From: Pease, Londell
Sent: Saturday, May 12, 2018 7:34 AM
To: 'Jacob Gullerud'
Cc: Erin Murray; Joe Dumond; Mike Carpenter
Subject: RE: Wendy's - 9624 Lyndale Avenue
Attachments: Wendys signs.pdf; Decision Notice 800160.pdf

PROJECT TYPE: CG3480
REFRESH

9624 LYNDALE AVE. S.
BLOOMINGTON, MN 55420

EXTERIOR ELEVATIONS

A2.1

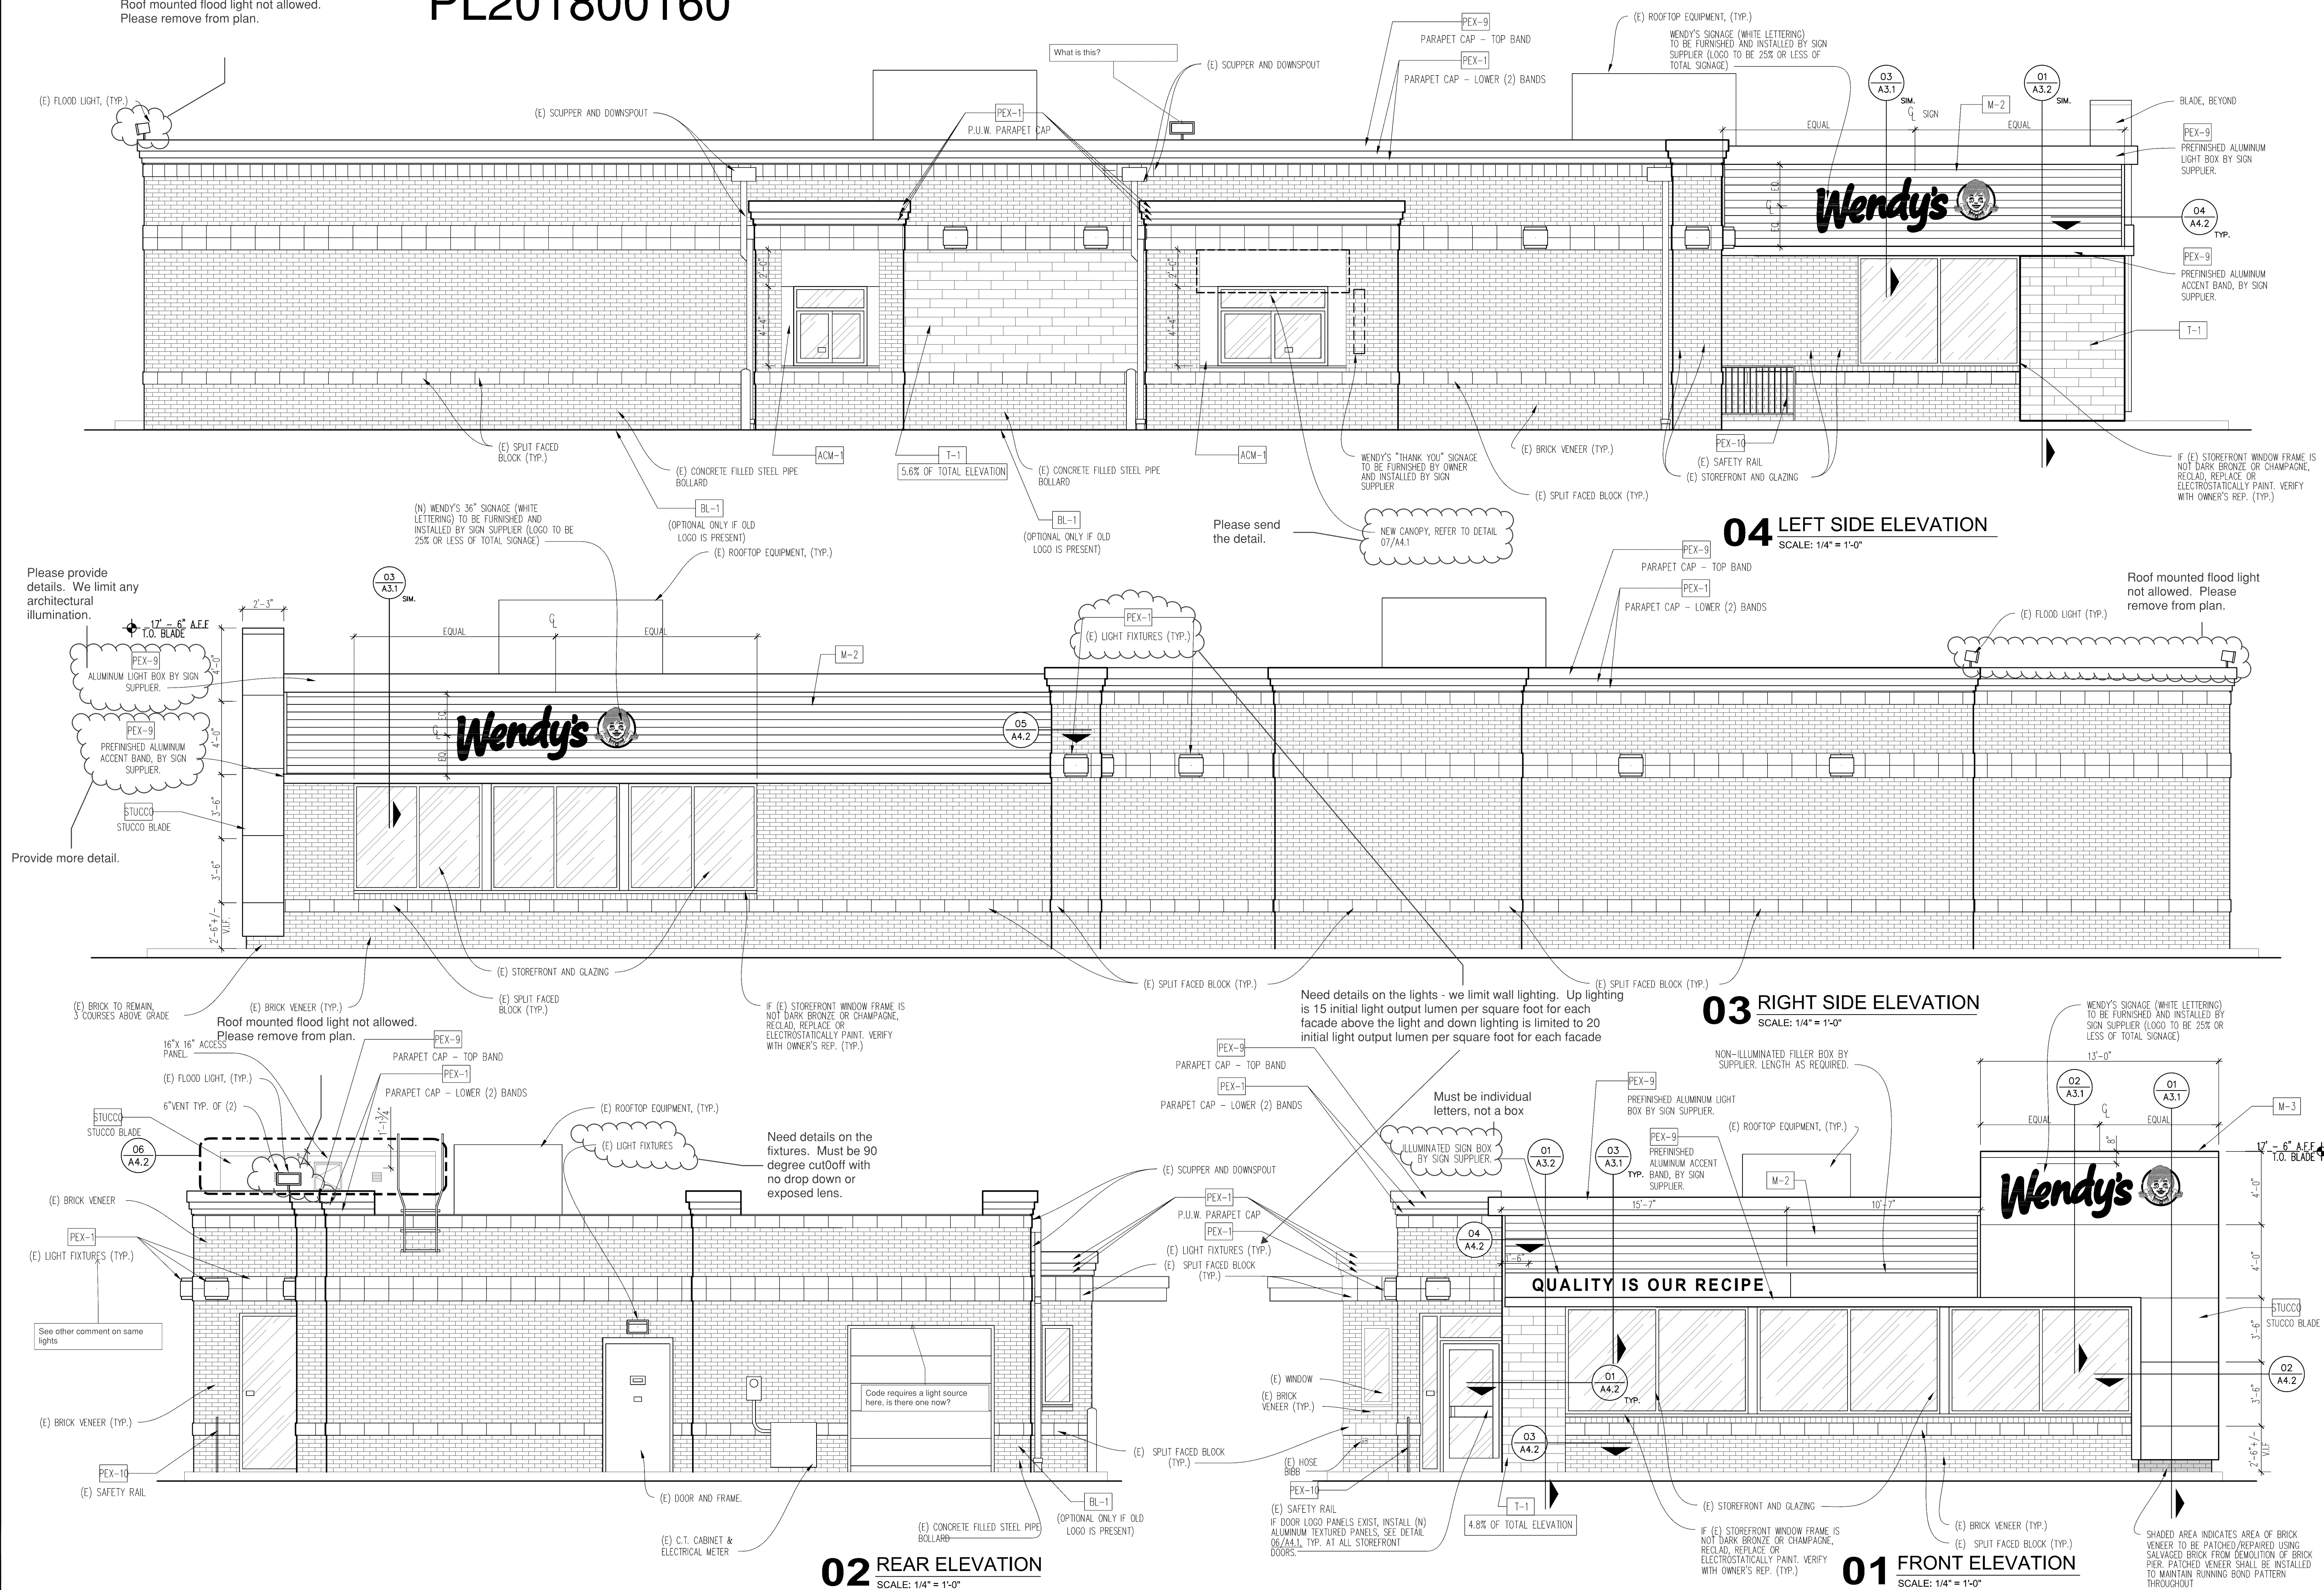
Thanks for the update, I will process as such. I have attached some comments on the plan attached and some clarifications and changes are required.

Also, I noted the wall signs on three sides? I see that is there not and did a permit history and there was never a permit for the third side. Not sure how they were placed on the building. Code allows wall signs on two walls only. In addition, the "sign" box with the "quality is our recipe" is not allowed. They can mount individual letters, assuming this is the side they chose to have signs, but the box is not allowed as you are limited to individual letters with the one logo cabinet per allowed façade. When I process for approval, I will redline and condition as such.

I've attached the exterior elevation sheet and marked up some of your comments, and also attached wall section and detail sheets for more detail on a few items. (I'm working on digging up cut sheets). Please ignore the metal panels that are shown for the exterior blade on the wall sections and details, I am in the process to changing these details to a stucco system.

1. Application fee has now been paid!
2. You noted that only 2 signs are allowed, I marked on the elevations that we will remove one from the plans.

3. The "QUALITY IS OUR RECIPE" sign will be changed to individual lettering.
4. Flood lights will be removed
5. All of the lighting on the exterior is existing, do you still need cut sheets on these? We are not intending on removing or replacing. (E) indicates an existing item.
6. I do not believe there is a light above the rear overhead door. I'll look into this and install an approved fixture if needed.
